**Project # PR-2018-001482**  
SI-2023-01925 - Site Plan - EPC

Tierra West, LLC, agent Riverside West, LLC, requests a new Site Plan-EPC, for all or a portion of Tract 1 of Summary Plat Land Division of West Land Development Co., included together with A Tract of land within these 1/4 SE, 1/4 SEC, 34 T10N, and R2E and a Tract of land east of Amole Del Norte Diversion Channel North of Section line of section 34 & 3, located at 2911 Ervien Ln. SW, north west of the intersection of Ervien Ln and Coors Blvd., approximately 42 acres. (M-10-Z)  
Staff Planner: William Steele

RE: PR- PR-2018-001482, SI-2023-01925–Site Plan-EPC \_ Riverside Mobile Home Park

LANDSCAPE PLAN

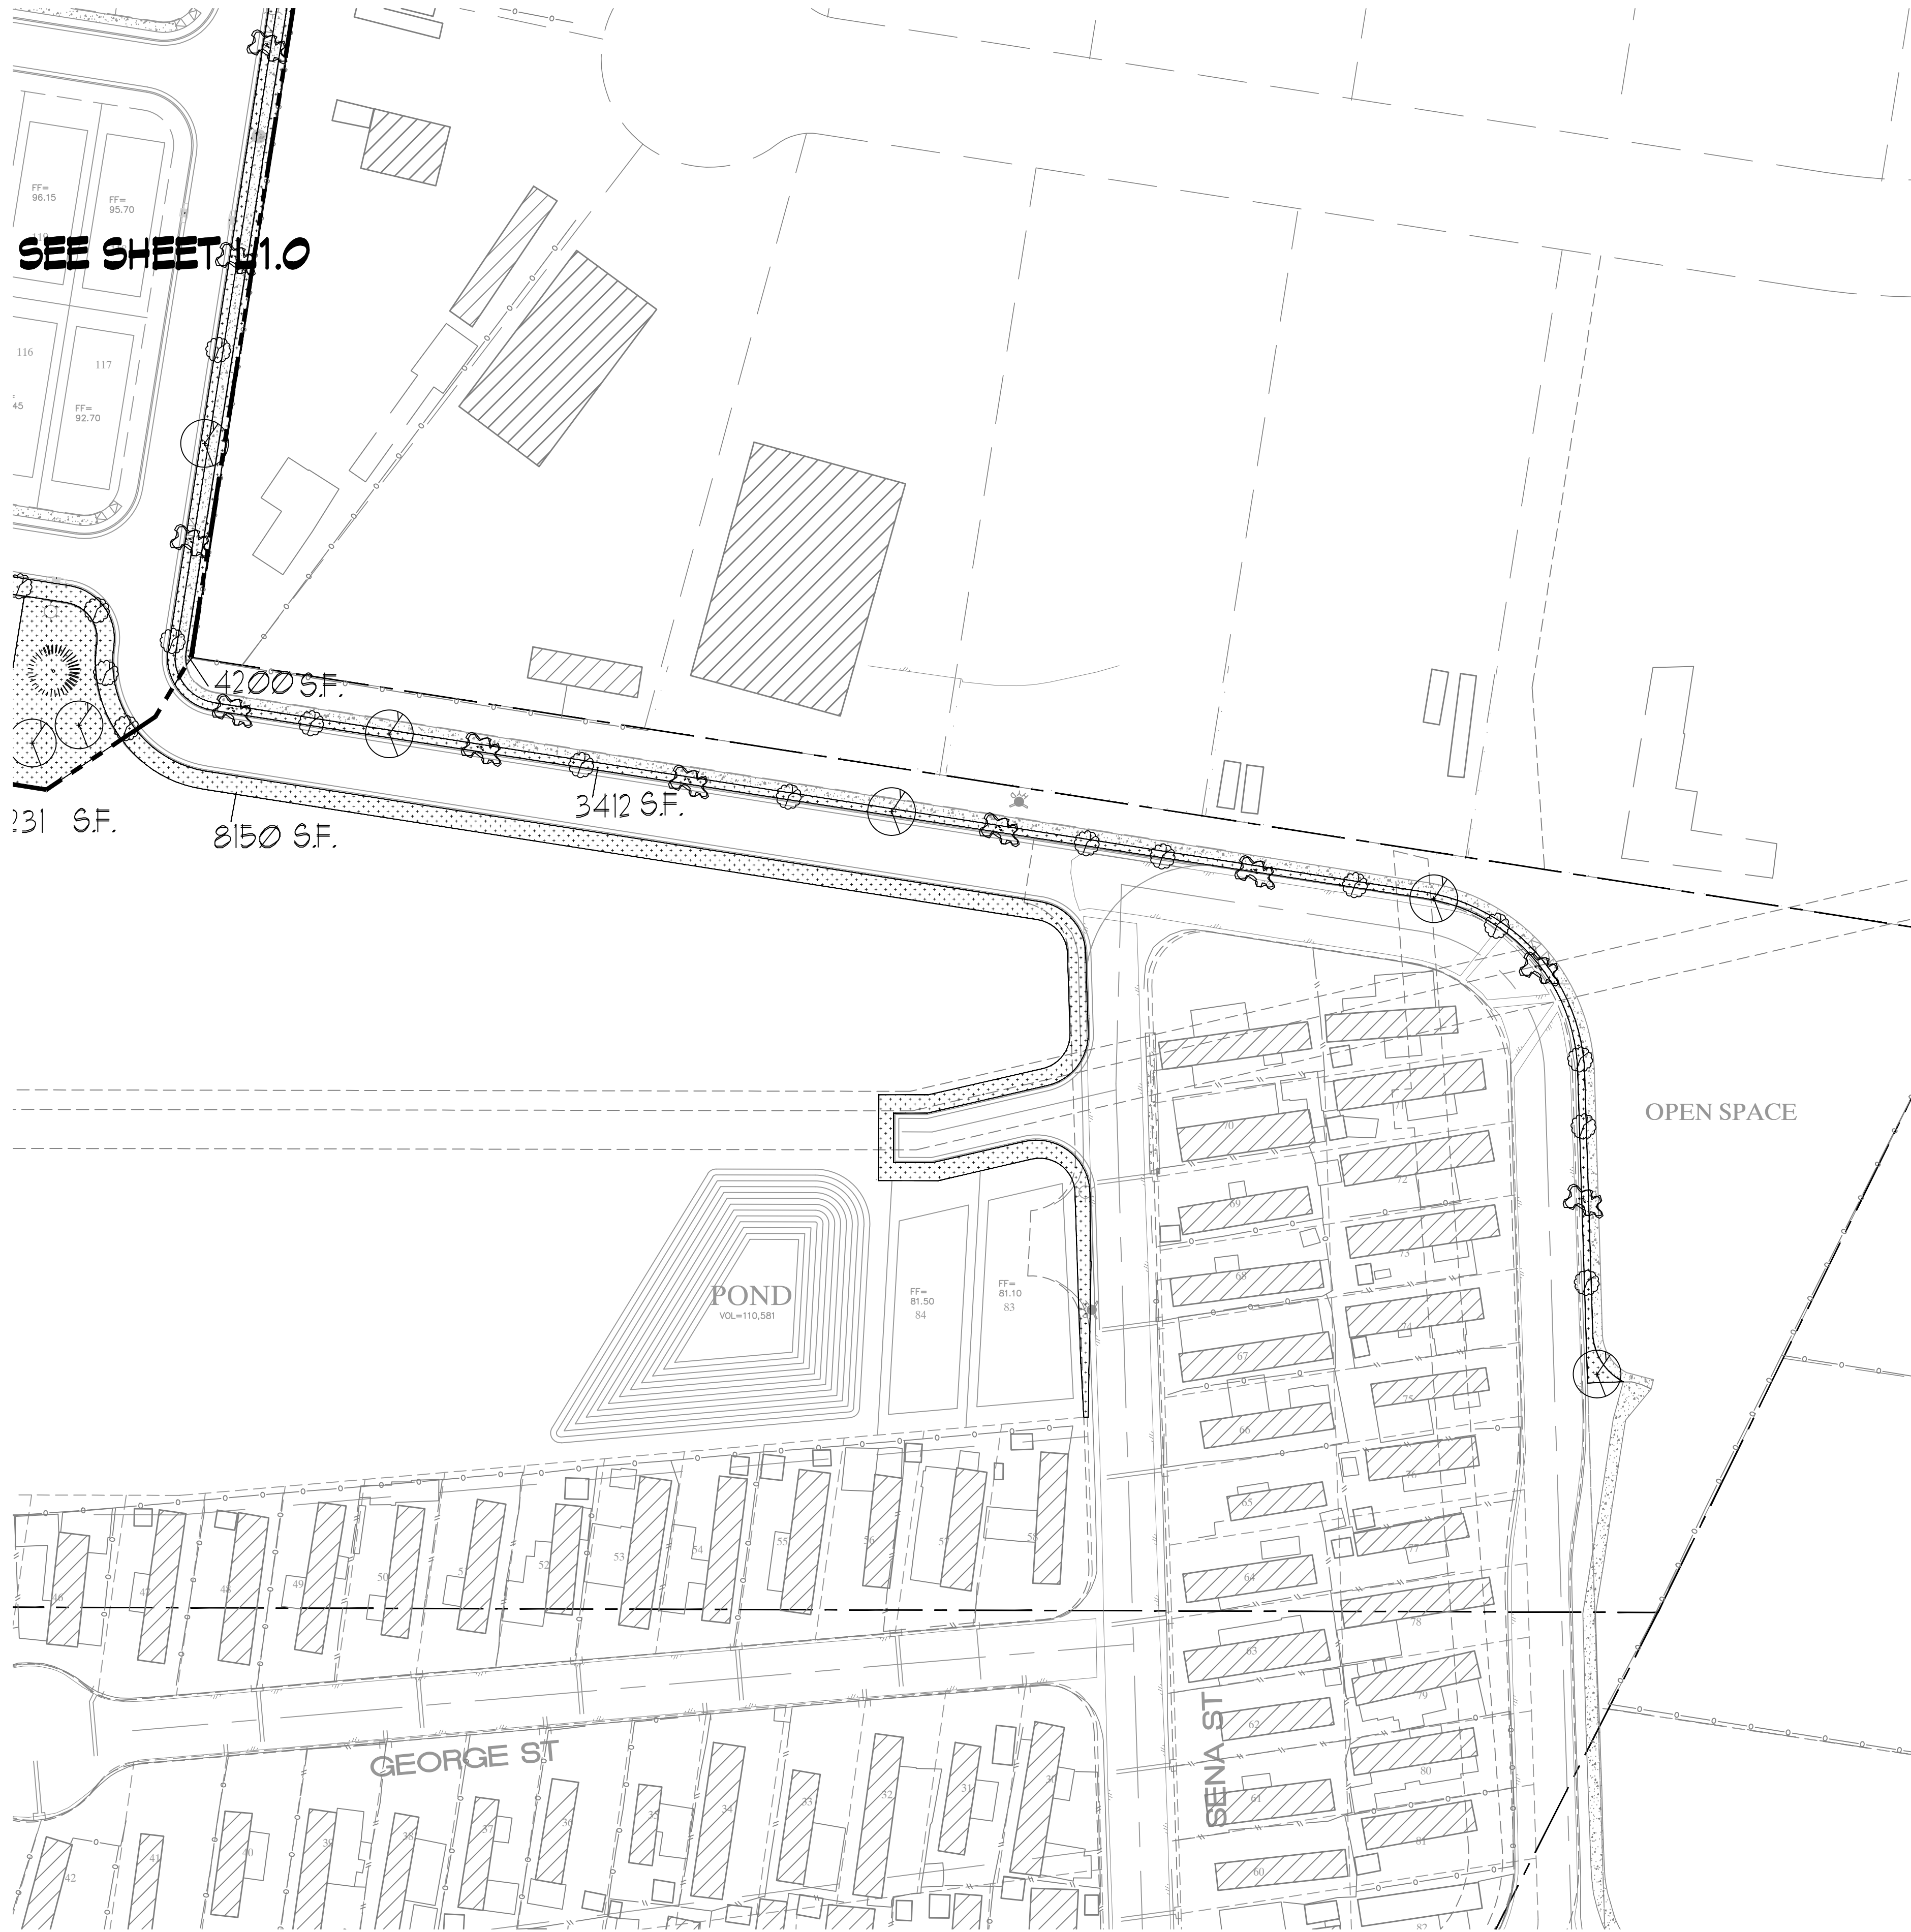
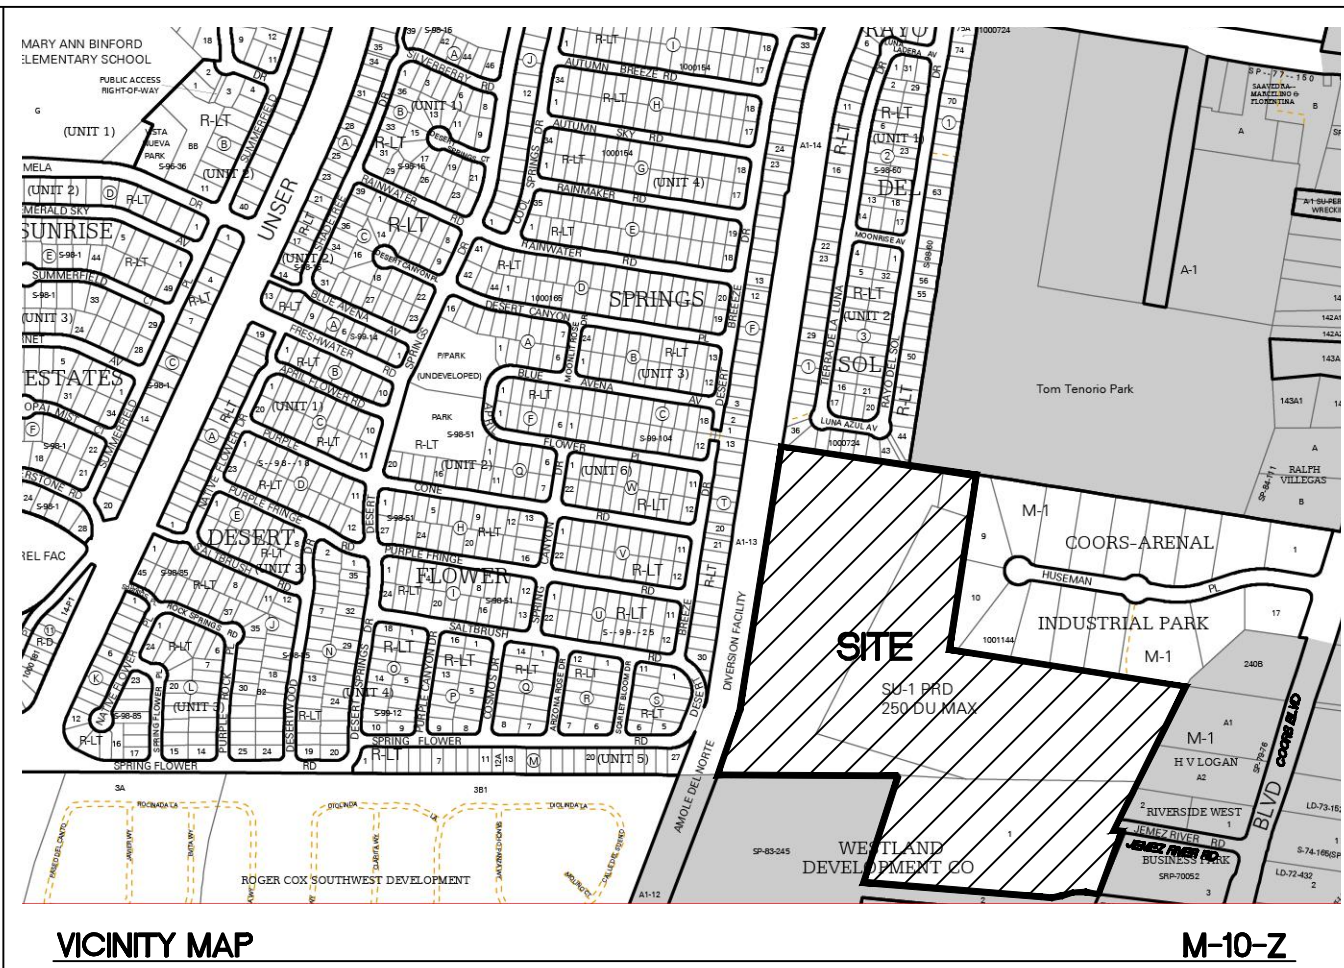
**Response:** Detail was reinstated.
3. **Comment:** The Landscape Sheet numbering has been changed from L1.0 to LS-101 and no longer matches the Index to Drawings on the Site Development Plan Sheet. Please revise.

**Response:** Sheet index was corrected to reflect the updated sheet numbering.
4. **Comment:** The Irrigation Notes have been removed from the Landscaping Sheet. Please reinstate.

**Response:** Irrigation notes were added back to sheet L1.0.
5. **Comment:** The location of the Drainage Basin Treatment Per City of Albuquerque on the Landscape Plan has been significantly reduced in size and the notes have been removed. Verify approval of changes with Hydrology.

**Response:** Ponding was not changed on the grading and drainage. Landscape sheet L2.0 reflects that by showing the same ponding volume.

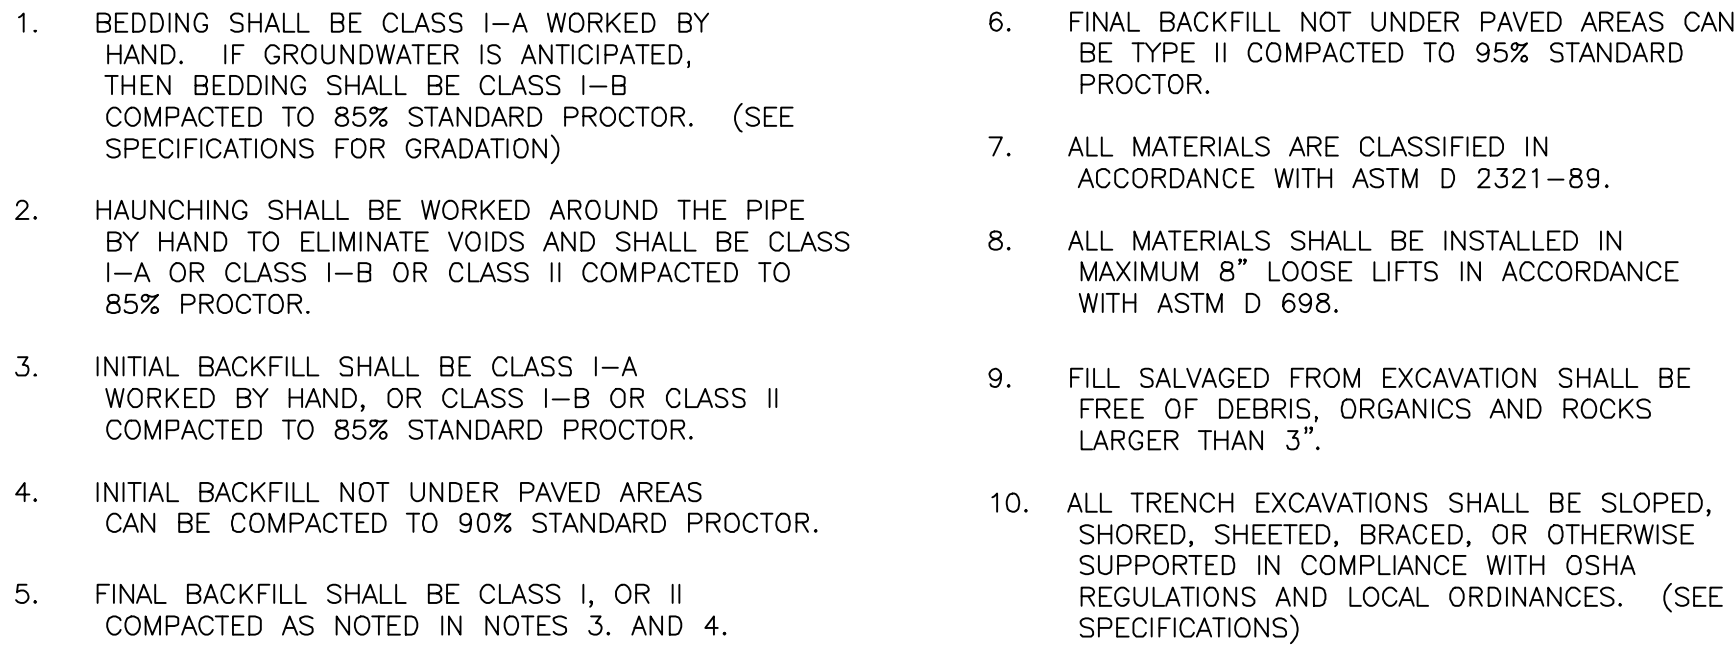
1. **Comment:** Sheets C4.0 Landfill Mitigation Plan and C5.0 Detail Sheet are missing from the set of drawings that were approved by the EPC. Please submit these drawings for review and to verify no unauthorized changes have been made that were not approved by the EPC.

**Response:** Sheets were added back into the plan set.
2. **Comment:** Detail Sheet C5.1, detail for Parallel and Diagonal Curb Ramps was removed. Please reinstate

ENGINEER'S SEAL	DATE: 1/3/2024
DRAWN BY: JL	DRAWING: 20220505-SP
SOUTH VALLEY MHP ALBUQUERQUE, NM	
SITE DEVELOPMENT PLAN	
SHEET # C10	
TERRA WEST LLC ALBUQUERQUE, NEW MEXICO 87109 www.terrawest.com	
1/3/2024	JOB # 20220505
VINCENT P. CARRICO P.E. 116212

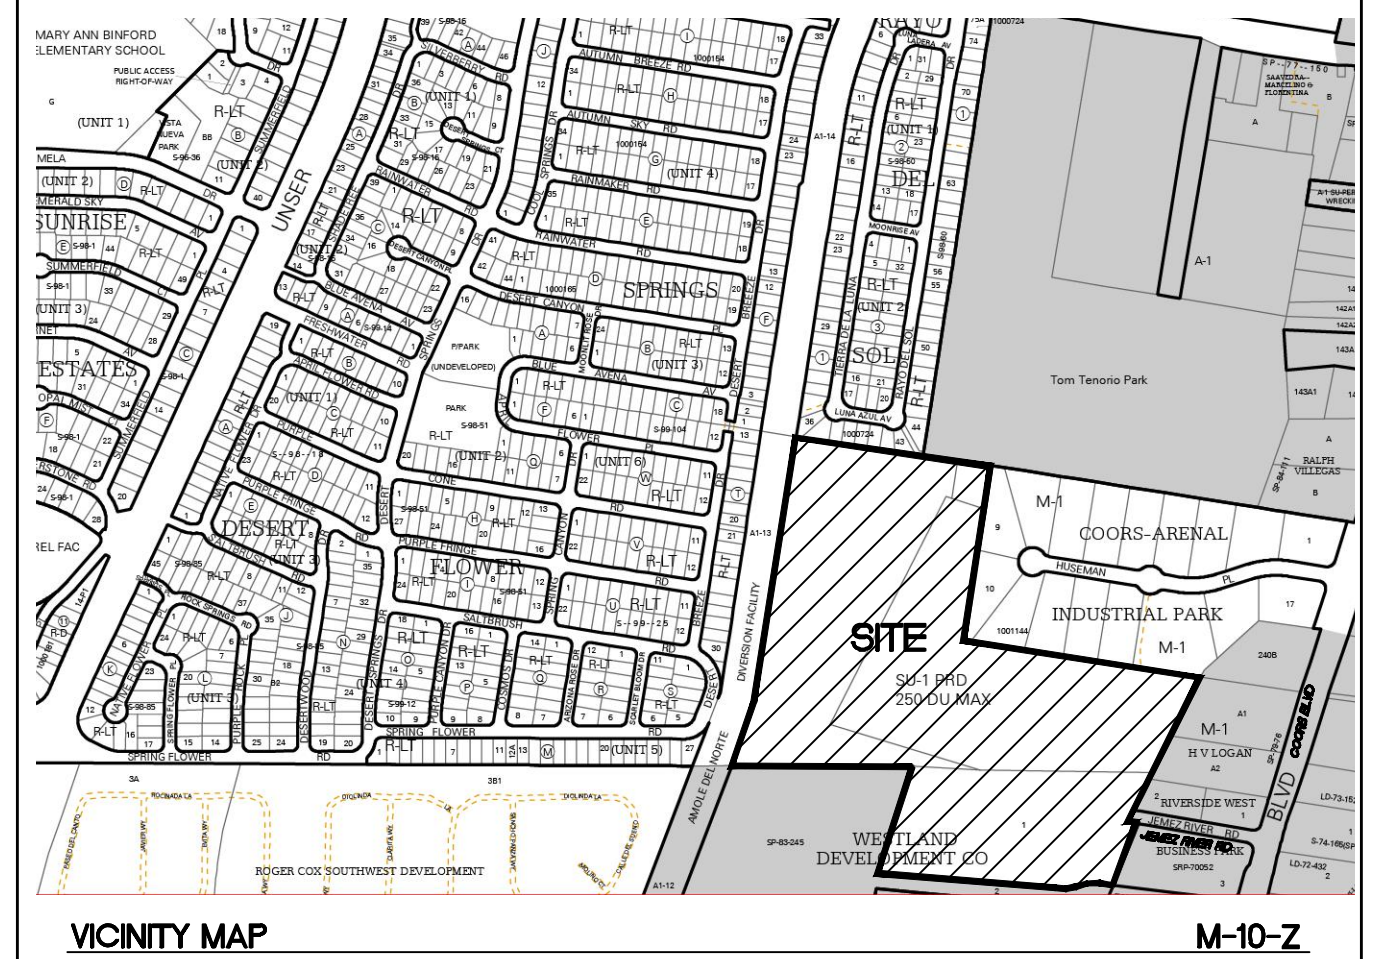
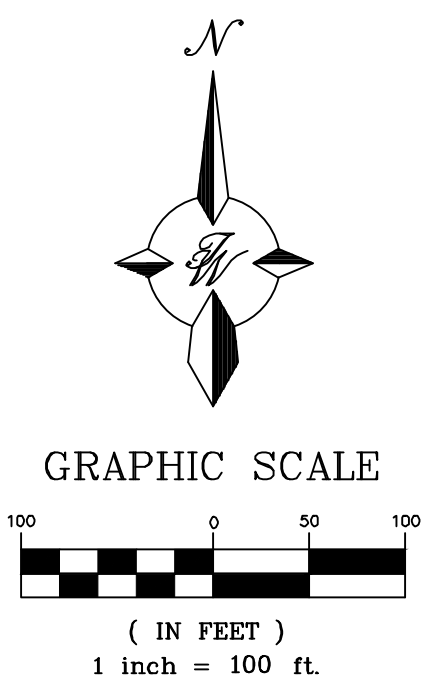
**Response:** All notes referring to lighting has been updated to reflect a maximum height of 16'
4. **Comment:** Condition 3b has been partially met. The site plan has not specified LANDFILL GAS BUFFER AREAS on the drawing or in the legend in parenthesis next the LANDFILL LIMIT.

**Response:** This action has been completed by adding "(LANDFILL GAS BUFFER AREAS)" to the site plan and legend.
5. **Comment:** Condition 4 has been satisfied. The note regarding landscape compliance has been changed to "Residential Manufactured Home Community on the Landscape Plan."
